Indian River County
Purchasing Division
1800 27th Street
Vero Beach, FL 32960
Phone (772) 226-1416

ADDENDUM NO. 3

Project Name: **North WWTF Headworks Piping Reconfiguration**

Bid Number: **2019063**

1.0 M.G.D. EXTENDED AERATION PLANT
PROCESS FLOW DIAGRAM
NO SCALE

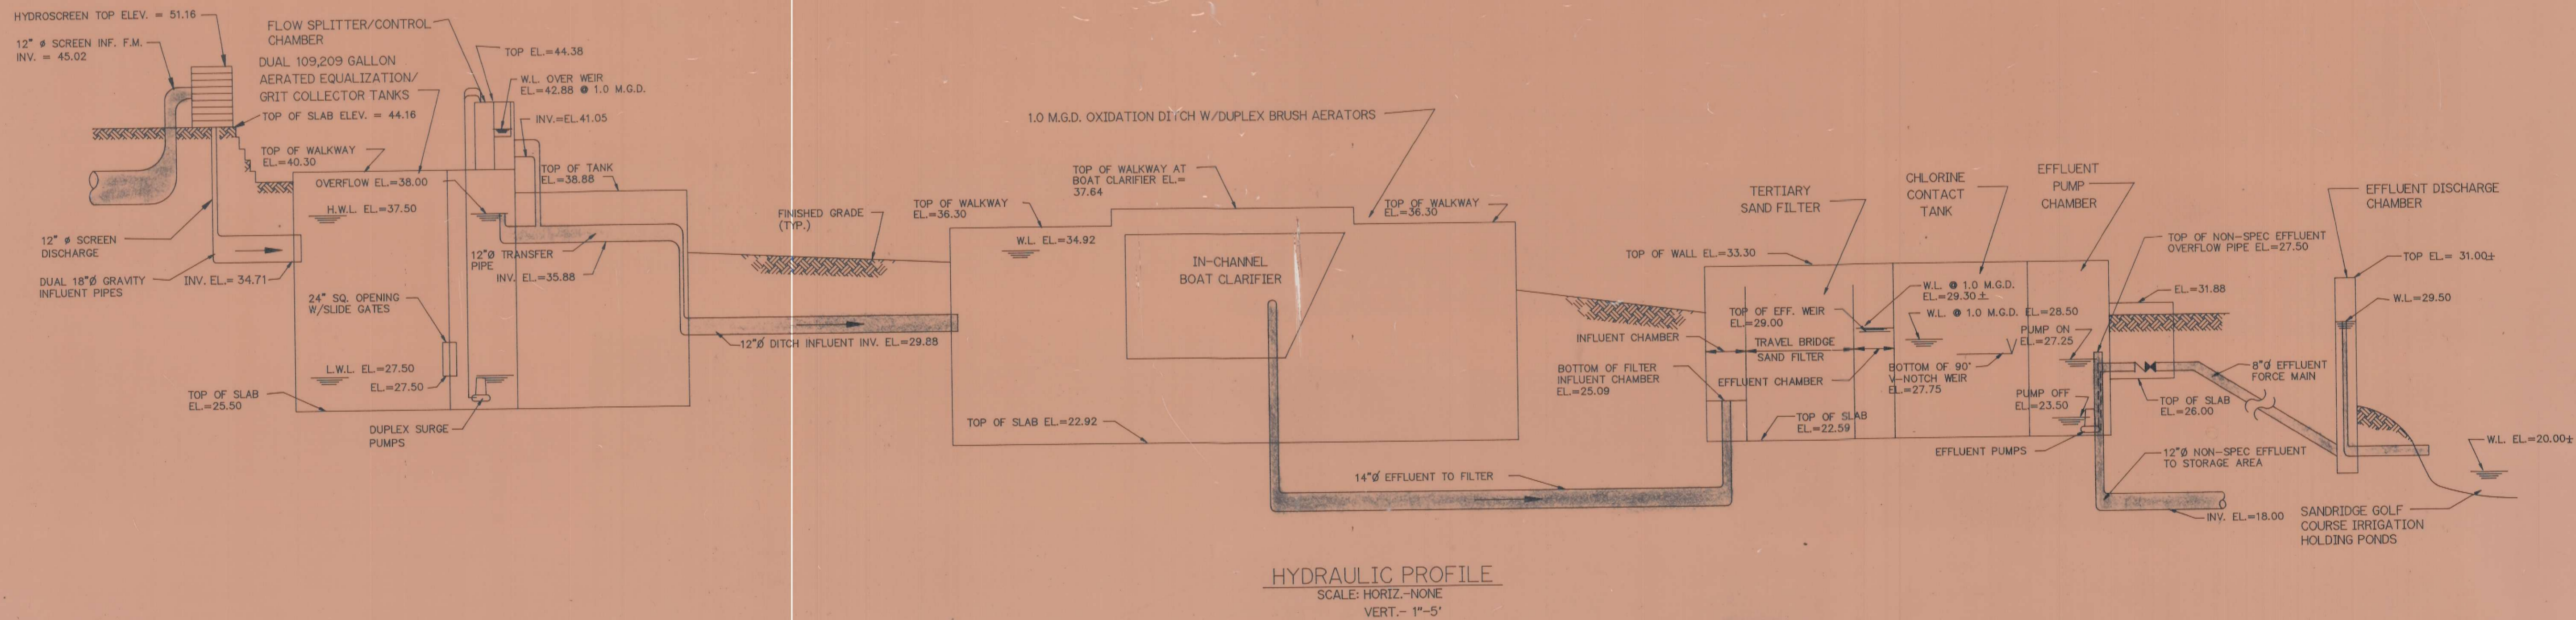
Question 1. Are as-built drawings showing the existing conditions available?

Answer: *See attached As-built drawings.*

BAR SCREEN/AERATED EQUALIZATION TANKS AND SLUDGE HOLDING TANK W/ BLOWERS

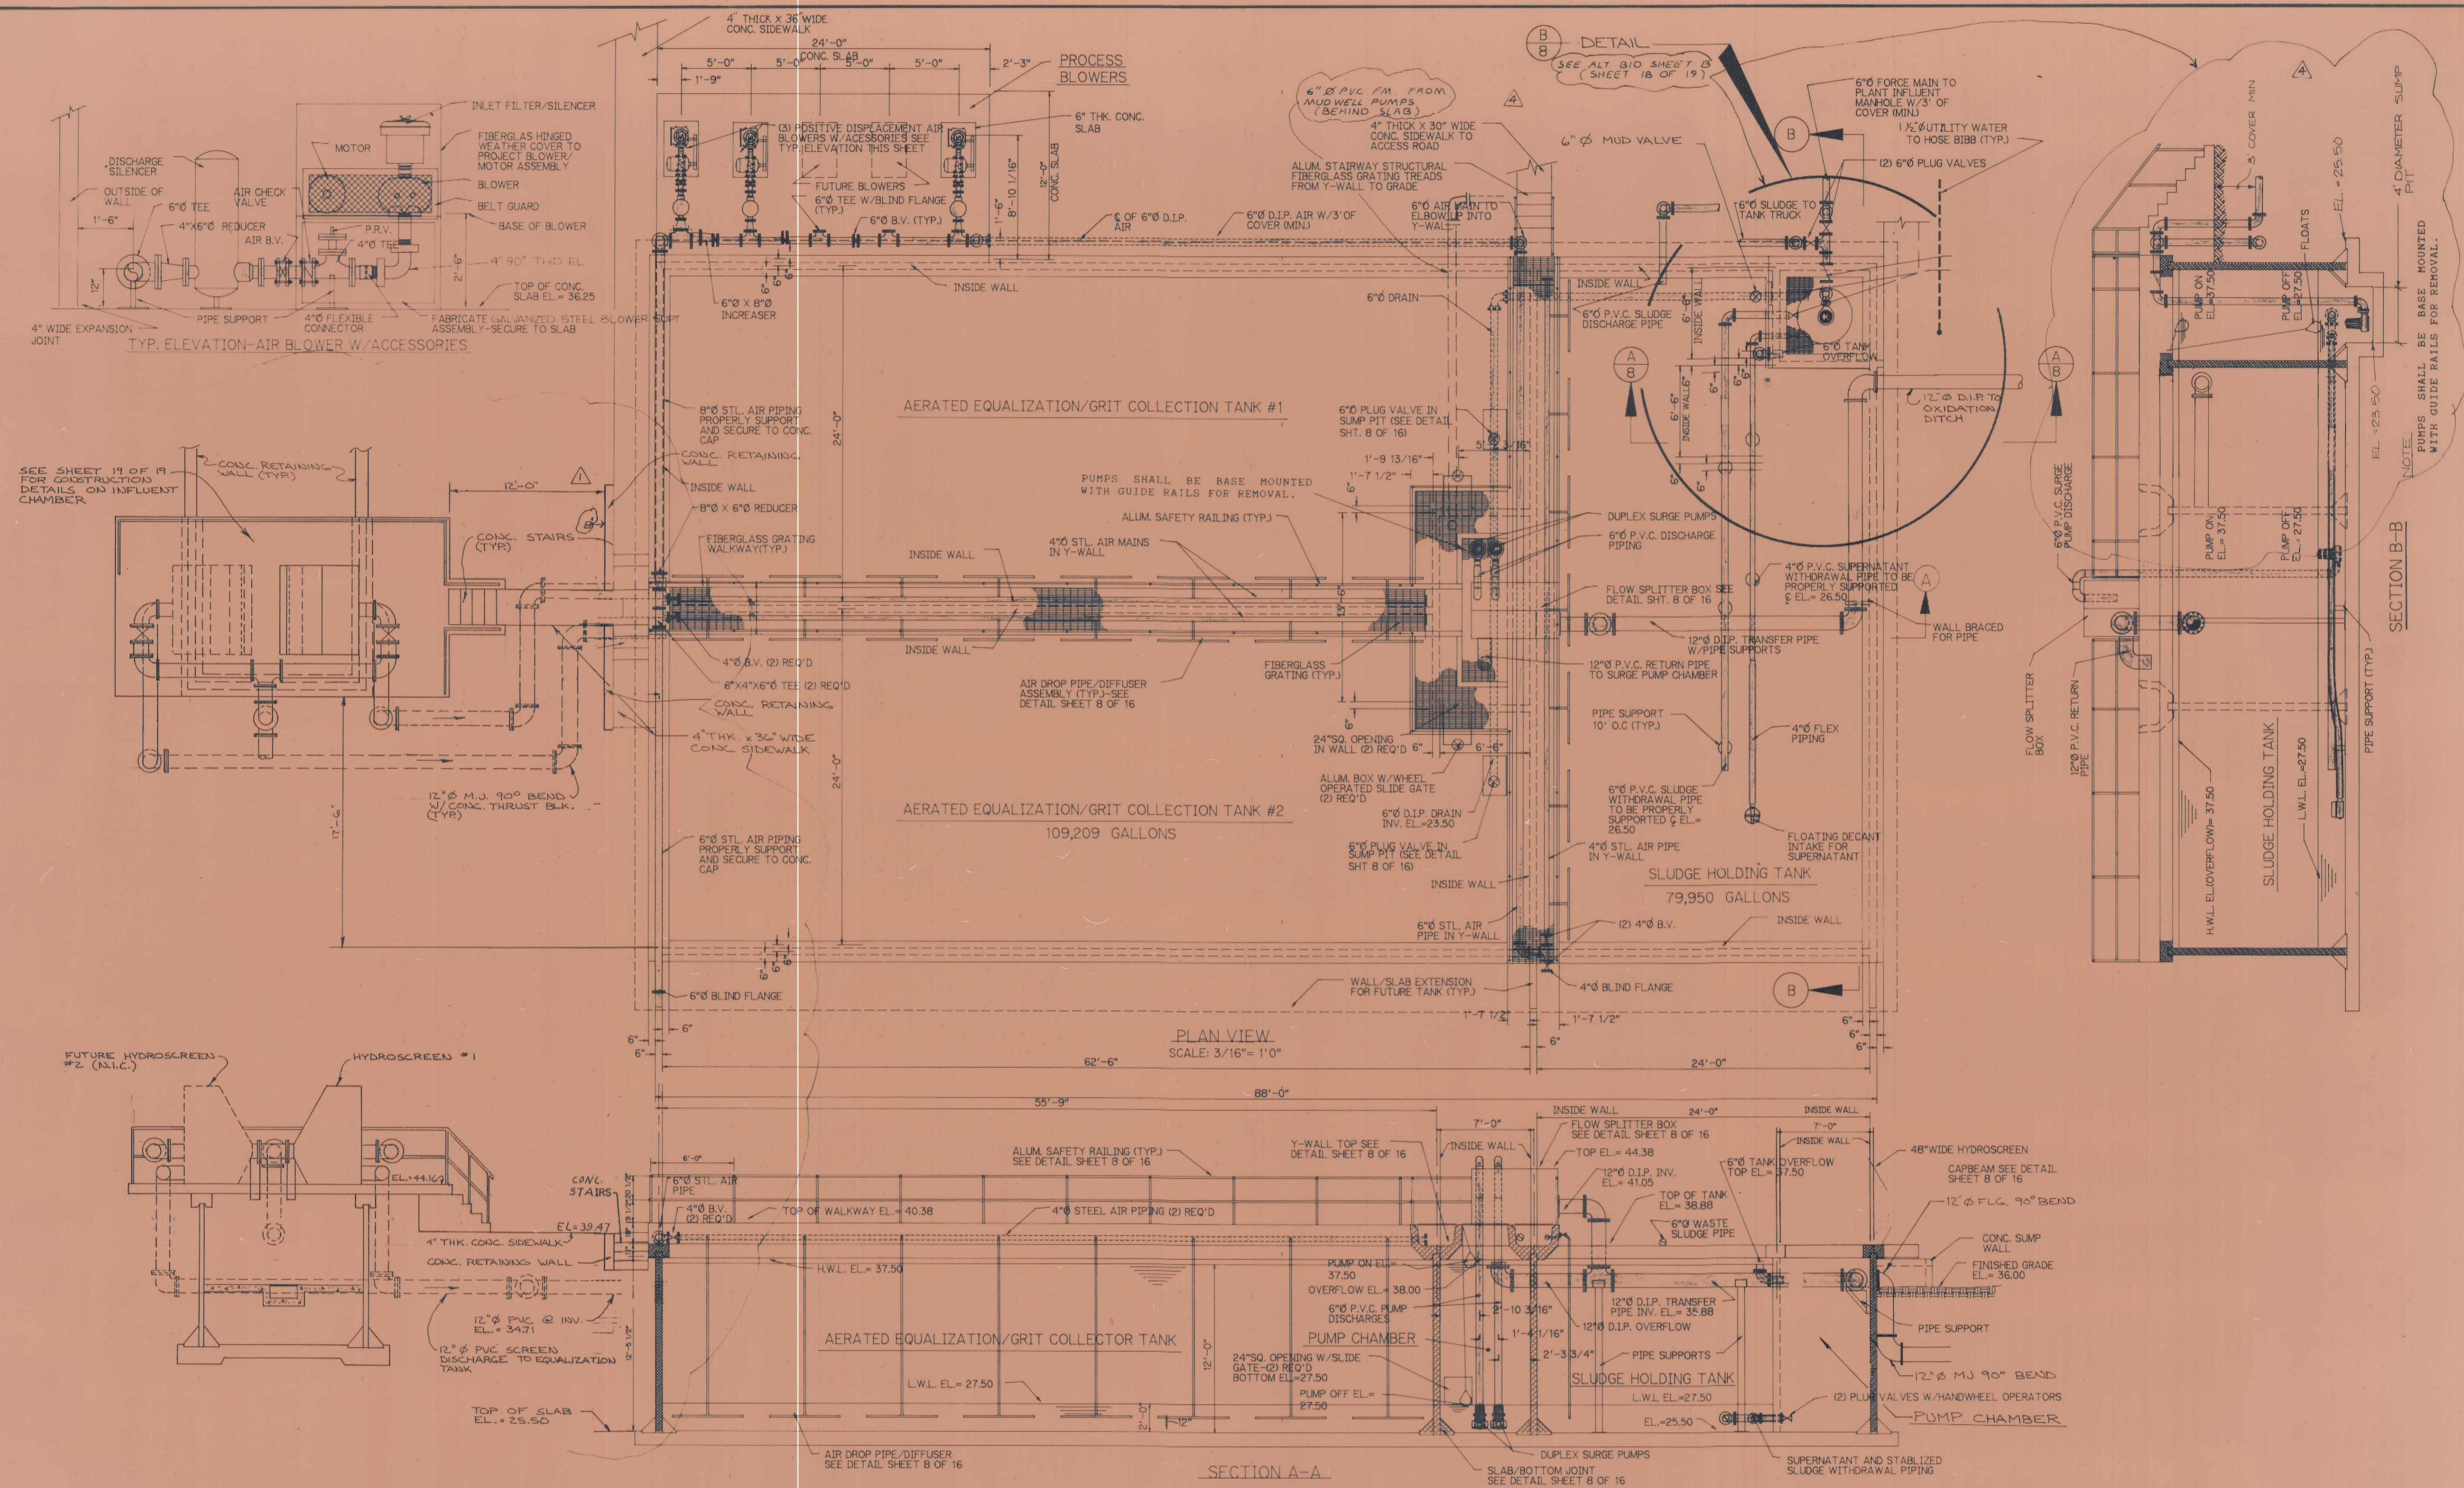
Question 3. Please provide elevation for new 24" base 90 degree elbow inside of Surge/Aeration Tanks 1 and 2.

Answer: *The elevation is left to the Contractor for convenience of installation of influent pipes; 7 ft. is the maximum height for the pedestal off tank floor as shown on plans.*
